# SUMMIT AT POWDER MOUNTAIN

## Phase 1D - Development Parcel D - Village Nests Condos

### CONSTRUCTION DRAWINGS

**MAKE CORRECTIONS**  
Weber Fire District  
10/29/2013 5:16:32 PM

SHEET NUMBER  
**1.00**

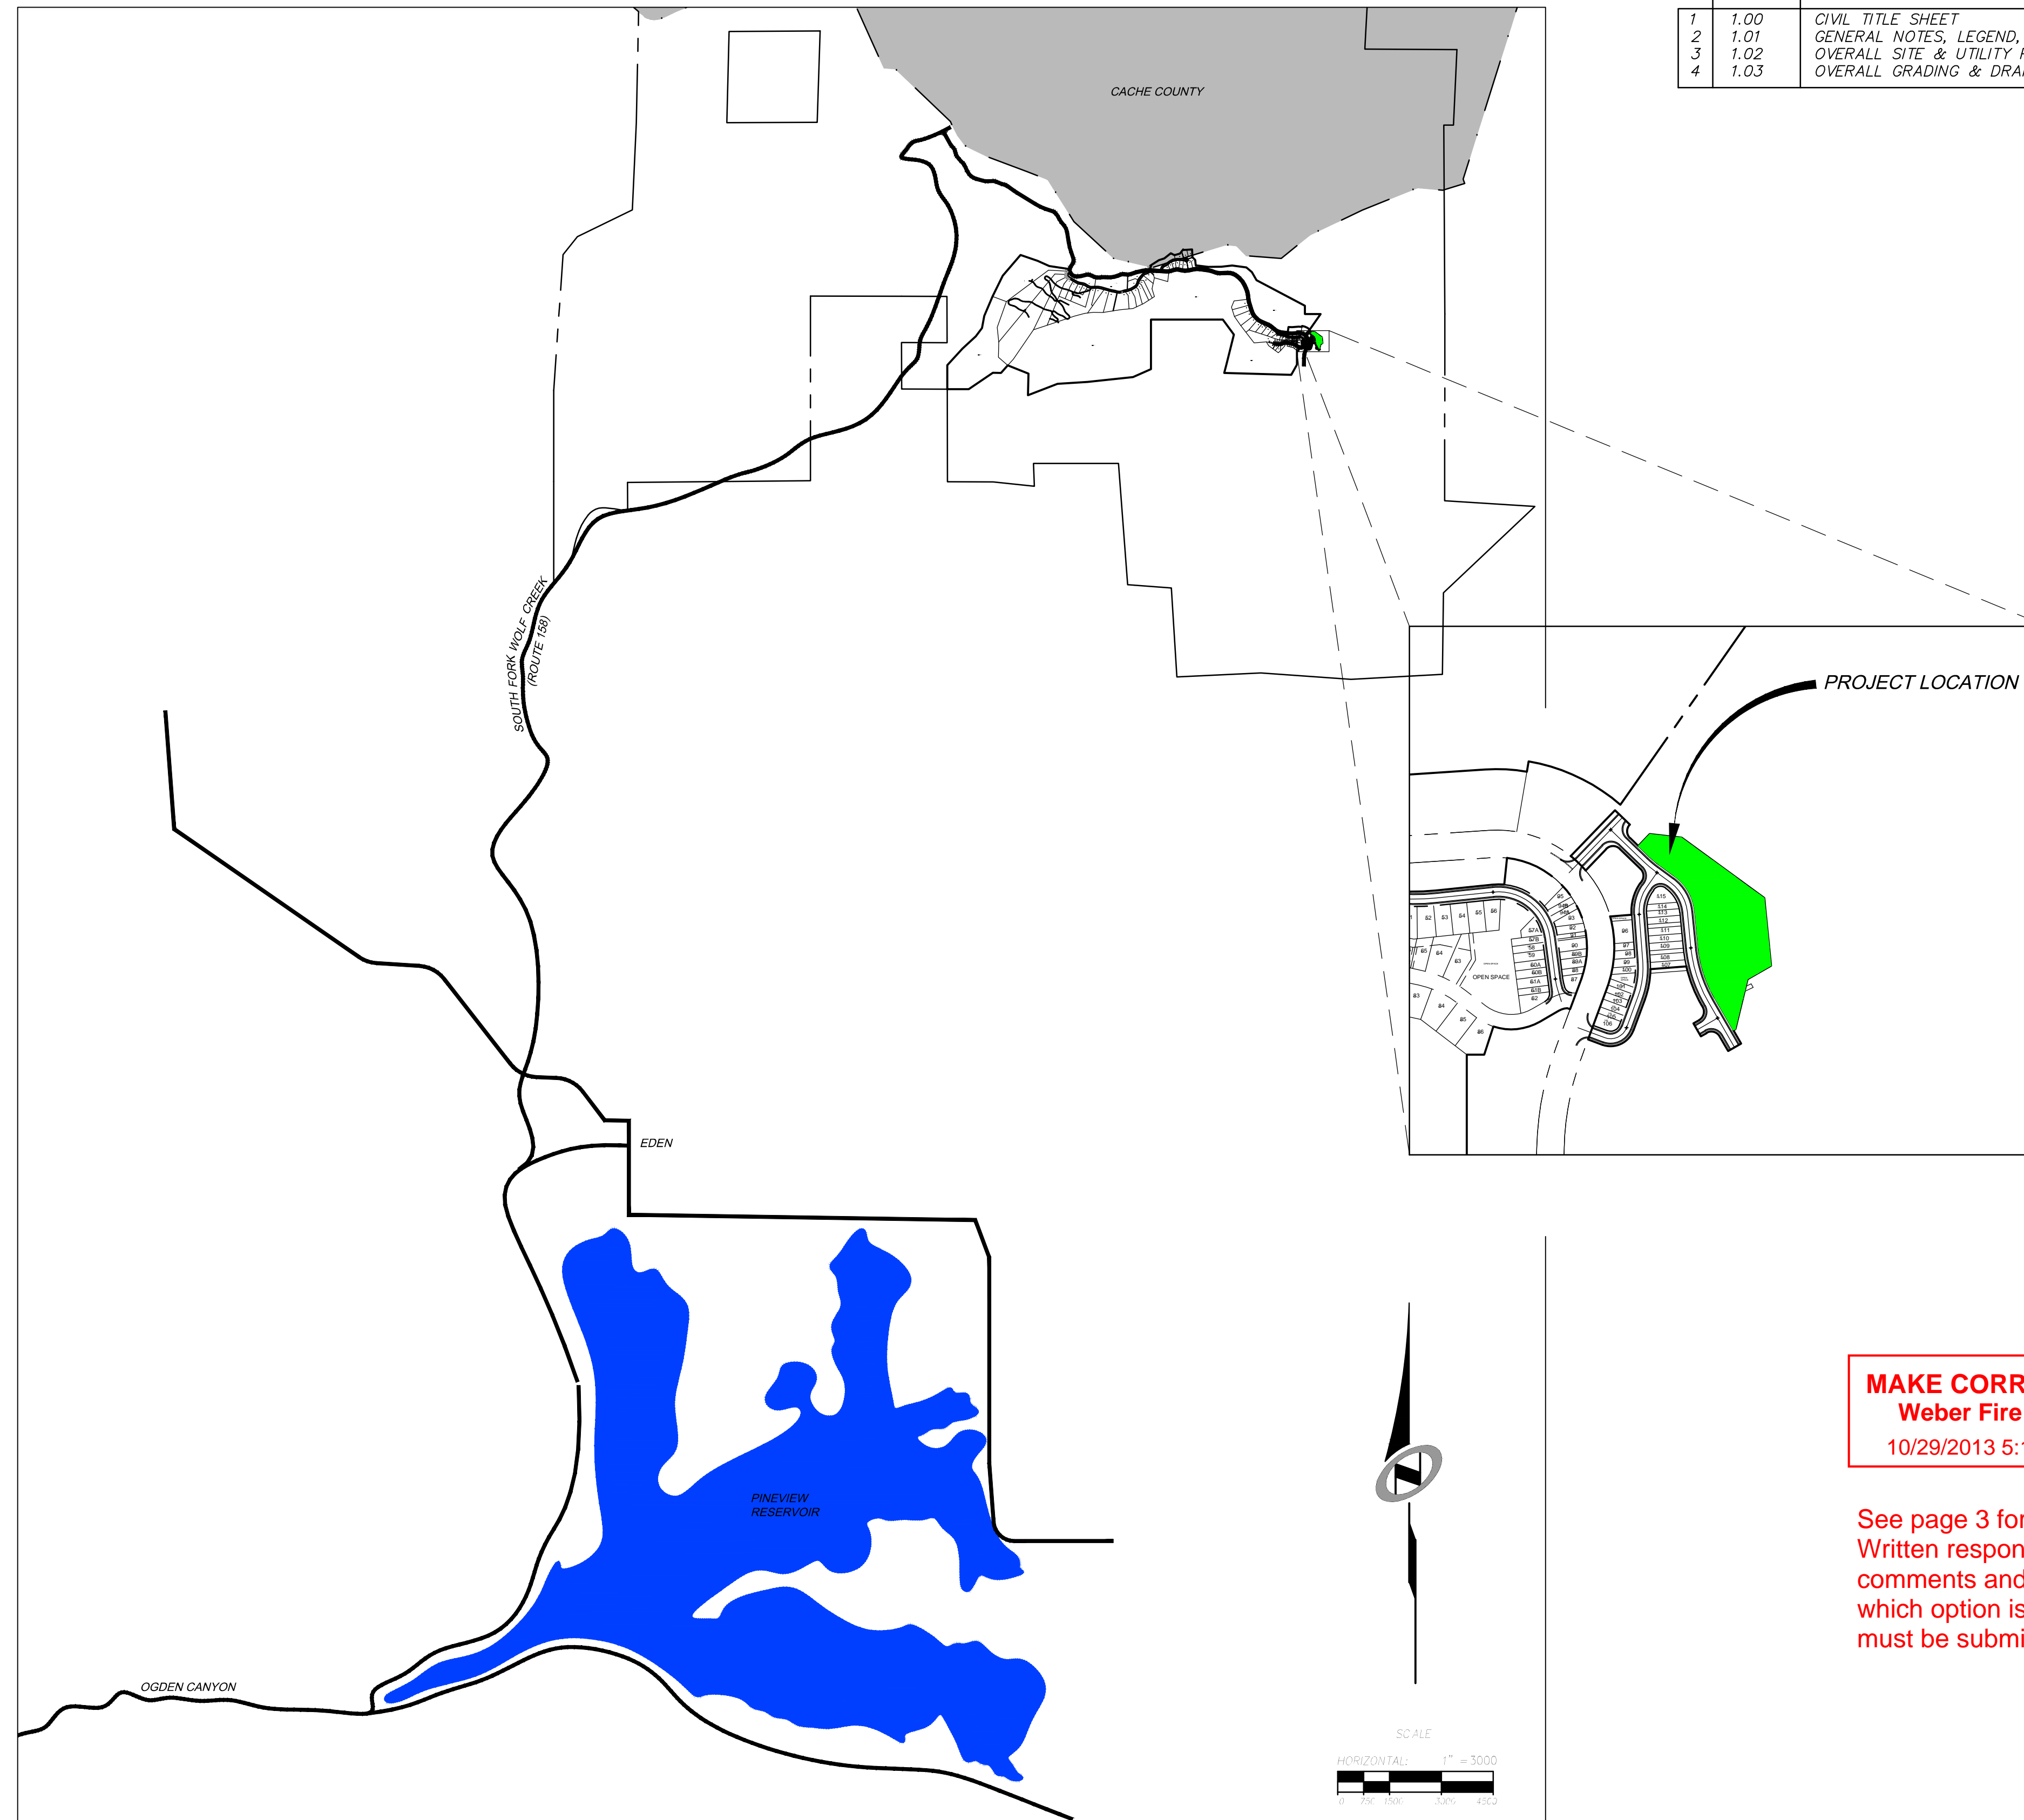
See page 3 for comments.  
Written response to the  
comments and declaration of  
which option is to be used  
must be submitted.
